Planning Permit

Use and development of the land for Motor Vehicle, Boat, or Caravan Sales (Car & Truck Rental) Please refer to the Planning Report for full application details.

Request for Further Information 2 Frederick Street, Sunbury Planning Application: P23784

PROPOSED SECTIONS

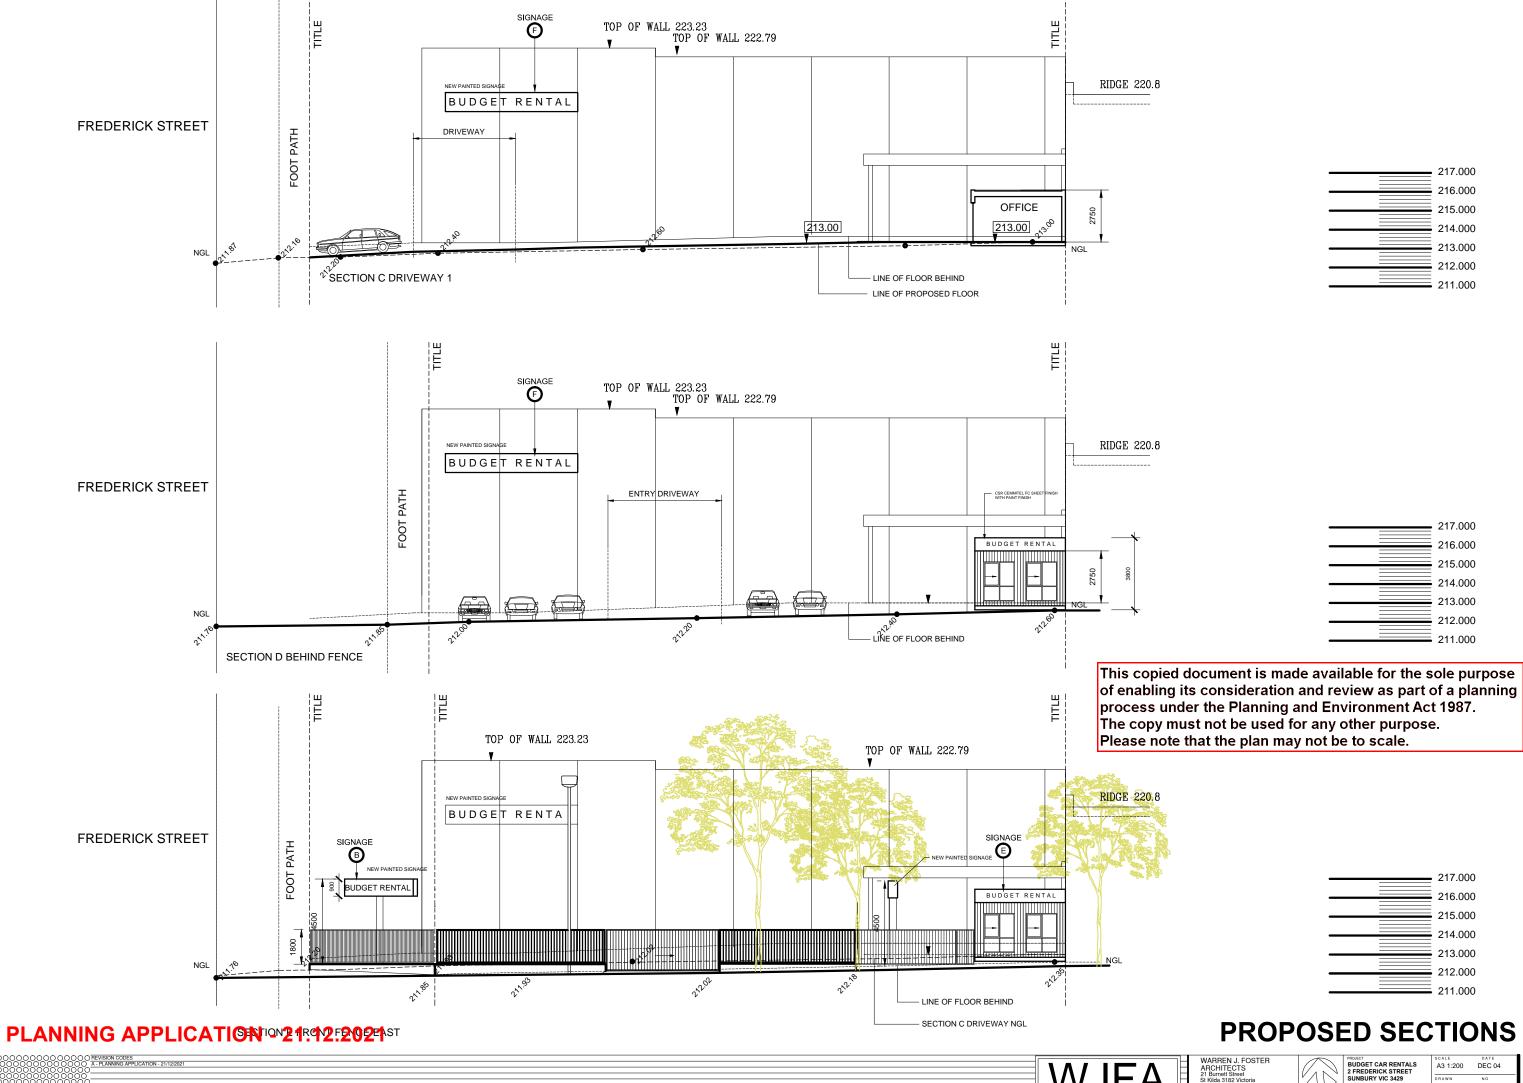
Please provide amended plans demonstrating that Covenant PS 639368N is met.

- 1. There is a 3m wide easement, which runs along the western boundary of the property. According to Council plans, Council's 525mm dia. stormwater pipe is located within the easement.
- 2. According to Council records, the pipe centreline is located 2m from the property boundary within the easement and is located at a depth of approximately 1.5m within the north-west corner of the site. As such, proposed footings for any brick or masonry buildings within 200mm of the easement must have a founding depth not less than 700mm below the existing ground surface level.
- 3. In order to maintain a minimum required cover over Council's assets, the maximum allowable cut within the easement is 230mm.

Please update the plans to ensure the proposal aligns with the above. Please note that the covenant on title also has minimum floor levels, so you may need to balance these.

The covenant requires a minimum finished floor level of 212.77. The plans have been amended to show compliance with Covenant PS 639368N, by providing a finished floor level of 213.25.

The plans have been amended to reflect the comments from Council's Engineers.
